# Site Accessibility Evaluation

## Americans with Disabilities Act Title II (Public Services: State and Local Government)

### County Professional Building

*Inspection Date: 07/24/2017*  
*Inspector: David Mejia*

### Finding: 1

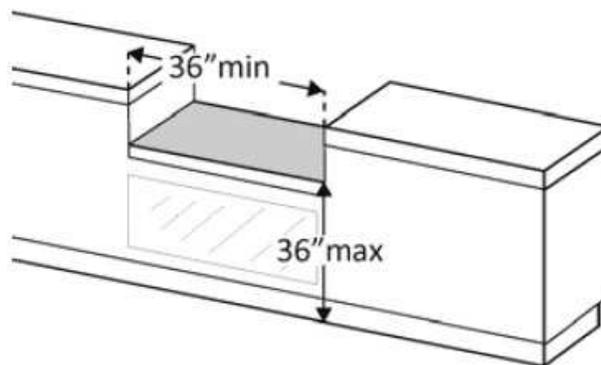
The transaction counter is too high.

*2010 ADAS Section 904.4.2*

36.25 inches above  
finished floor

Install new counter section that measures 36 inches maximum in height from the finish floor and lengthen that section of the counter to 36 inches minimum. A clear floor or ground space shall be provided for either a parallel or forward approach complying with section 305 and/or 306 respectively.

### Finding: 2

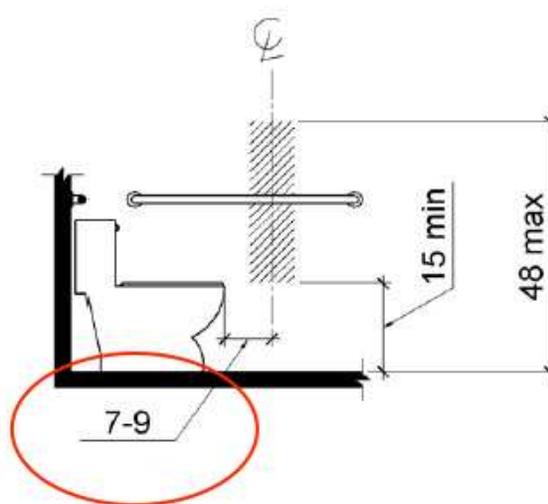
The toilet paper is not installed within the compliant range.

*2010 ADAS Section 604.7*

5 inches in front of toilet

Re-position toilet paper dispenser to be within 7 inches minimum to 9 inches maximum in front of the toilet measured to the centerline of the dispenser.

### Finding: 3

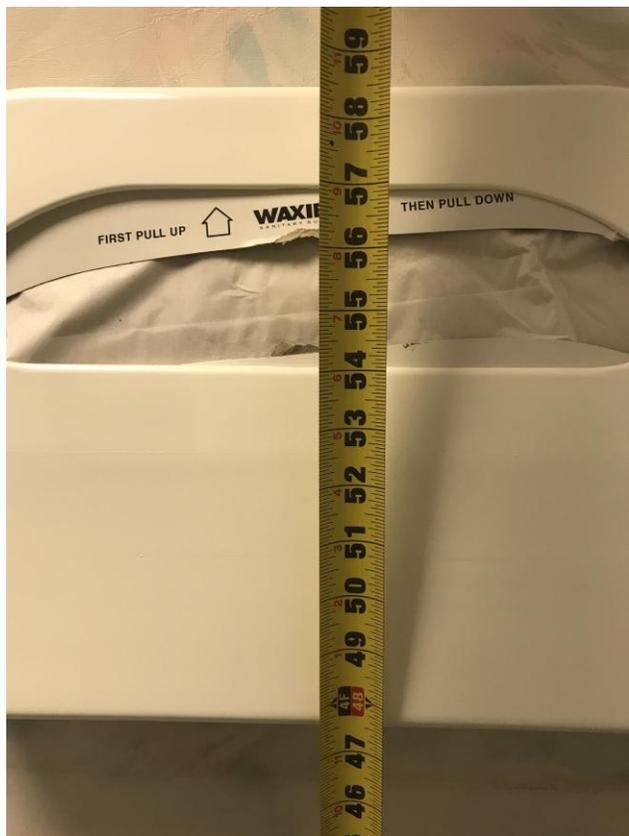
The toilet seat cover dispenser is mounted too high.

Citation:	As Built:	Budgeting Range:
2010 ADAS Section: 308.1	54 inches above finished floor	\$150 - \$1,500.00

Re-locate toilet seat cover dispenser below either grab bar at least 1.5 inches minimum below grab bars but no less than 15 inches above finished floor to meet compliance.

### Finding: 4

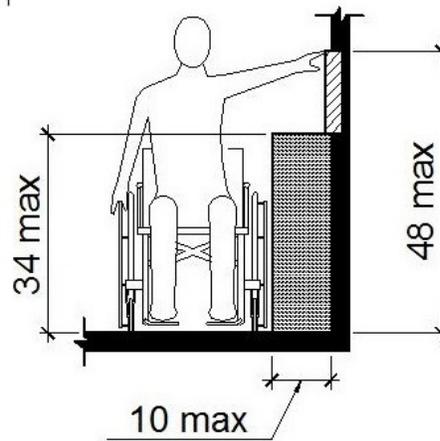
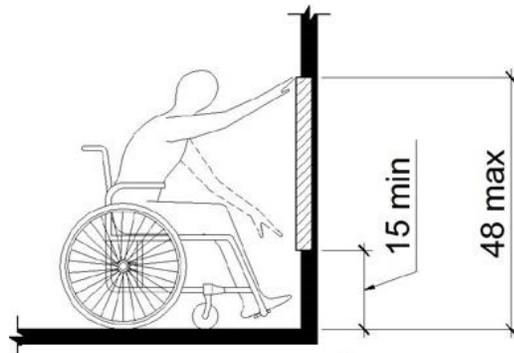
The coat hook is installed greater than 48 inches above the finished floor.

*2010 ADAS Section 308.2.1*

55 inches above  
finished floor

Lower coat hook 8 inches minimum or install another coat hook not to exceed a maximum height of 48 inches above finished floor.

### Finding: 5

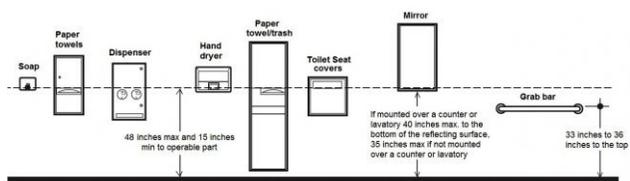
The paper towel dispenser's operation mechanism is too high off the floor.

*2010 ADAS Section 308.2.1*

58.5 inches above  
finished floor

Lower paper towel dispenser 11 inches to meet compliance. 48 inches maximum height above finished floor for operable parts (sensor).

### Finding: 6

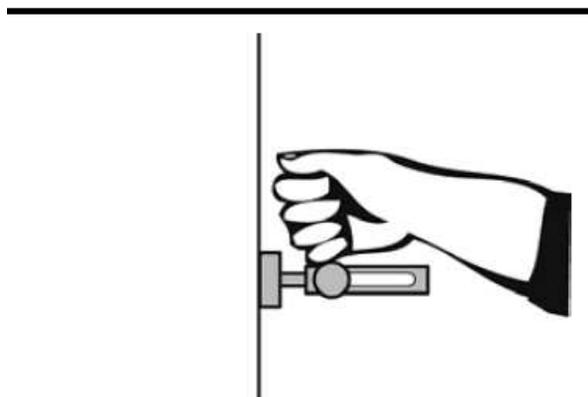
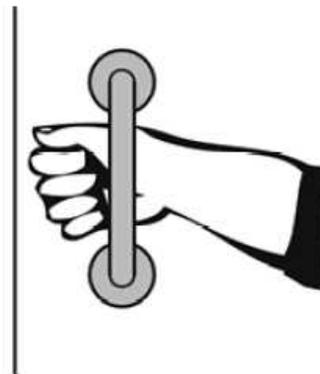
The locking/latching hardware is not accessible.

*2010 ADAS Section 604.8.1.2*

Locking hardware  
requires twisting and  
pinching of the wrist

Replace locking hardware with locking lever that does not require tight grasping, tight pinching or twisting of the wrist to operate.

Corrective Action: W/O 381216 completed 381216.

### Finding: 7

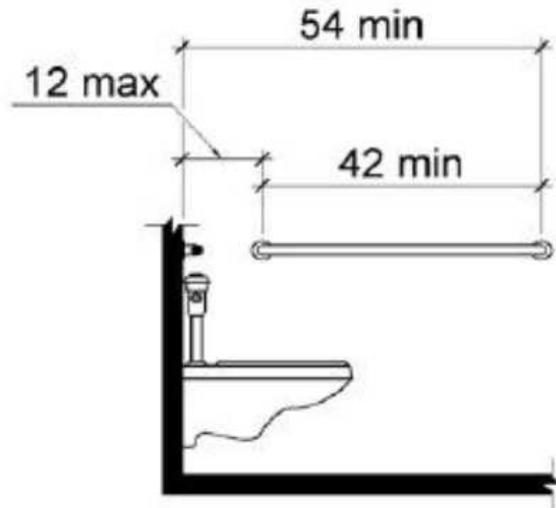
The side grab bar is located greater than 12 inches from the rear wall.

*2010 ADAS Section 604.5.1*

<b>Citation:</b>	<b>As Built:</b>	<b>Budgeting Range:</b>
2010 ADAS Section: 604.5.1	12.75 inches from rear wall	\$150 - \$1,500.00

Adjust side grab bar not to exceed 12 inches from rear wall. The side grab bar must be 42 inches minimum in length and extend at least 54 inches minimum beyond the rear wall.

Corrective Action: W/O 381204 submitted. Relocated grab bar- 3/23/17.

### Finding: 8

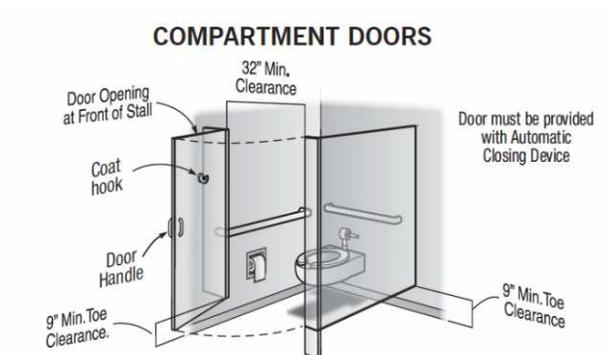
The compartment door is not self closing.

*2010 ADAS Section 604.8.1.2*

Stall door does not self-close

Adjust or install automatic closing hinges.

Corrective Action: W/O 381208 submitted. Replaced hinges, parts on hand. 6/19/17.

### Finding: 9

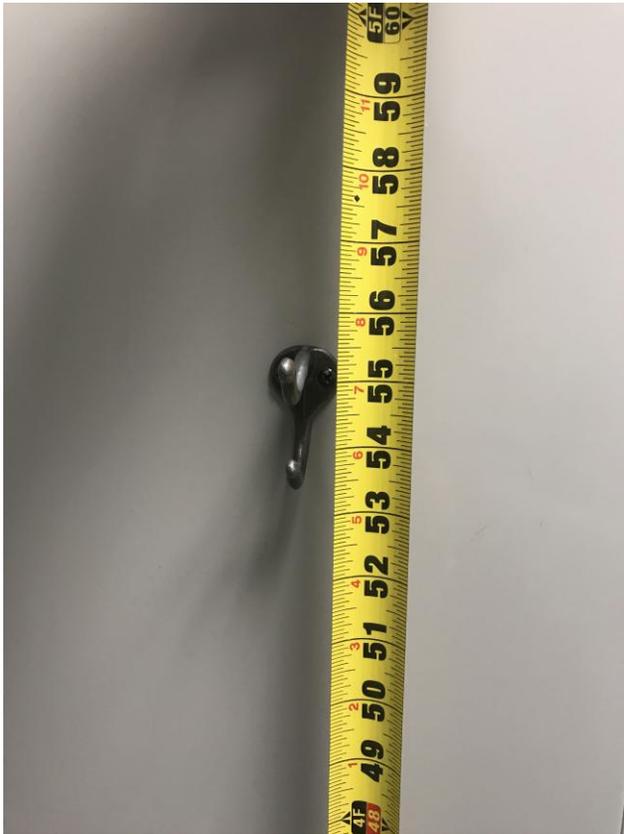
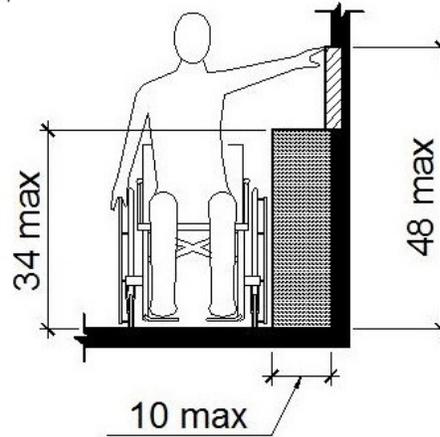
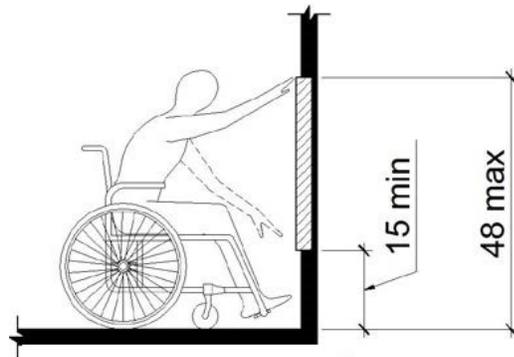
The coat hook is installed greater than 48 inches above the finished floor.

*2010 ADAS Section 308.2.1*

55 inches above  
finished floor

Lower coat hook 8 inches minimum or install another coat hook not to exceed a maximum height of 48 inches above finished floor.

### Finding: 10

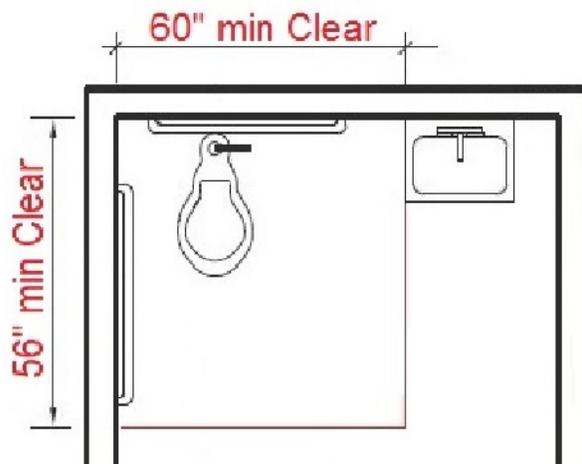
The clear floor space around the toilet is obstructed by the baby changing station.

*2010 ADAS Section 604.3.2*

Baby changing station projects into required cleared floor space of toilet

Remove baby changing station from inside compartment, Install in outer walls of restroom if space allows.

### Finding: 11

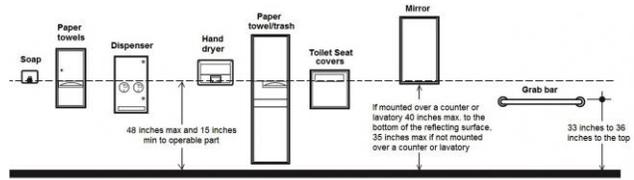
The toilet seat cover dispenser is mounted too high.

*2010 ADAS Section 308.1  
Reach ranges shall comply with 308.*

Citation:	As Built:	Budgeting Range:
2010 ADAS Section: 308.1	55 inches above finish floor	\$150 - \$1,500.00

Re-locate toilet seat cover dispenser below either grab bar at least 1.5 inches minimum below grab bars but no less than 15 inches above finished floor to meet compliance.

### Finding: 12

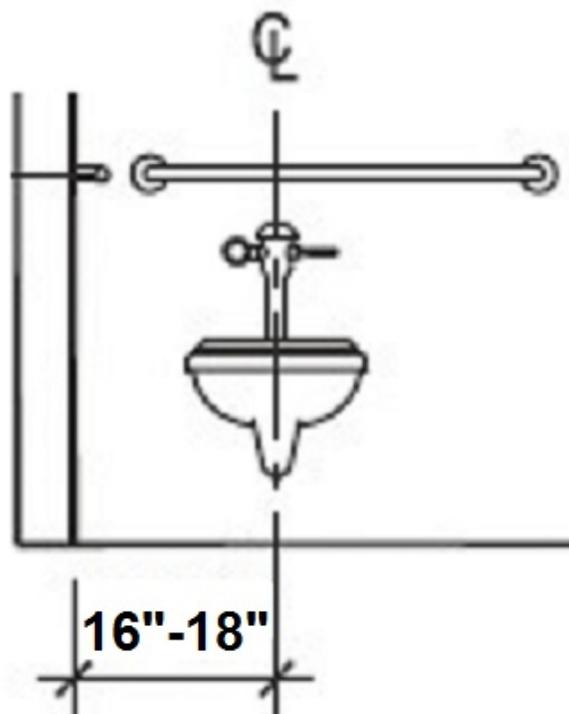
The toilet is not located within the range allowed from the side wall or partition.

*2010 ADAS Section 604.2*

18.75 inches from side wall

Re-position toilet between 16 inches minimum and 18 inches maximum from centerline of toilet to side wall. May require plumbing alteration.
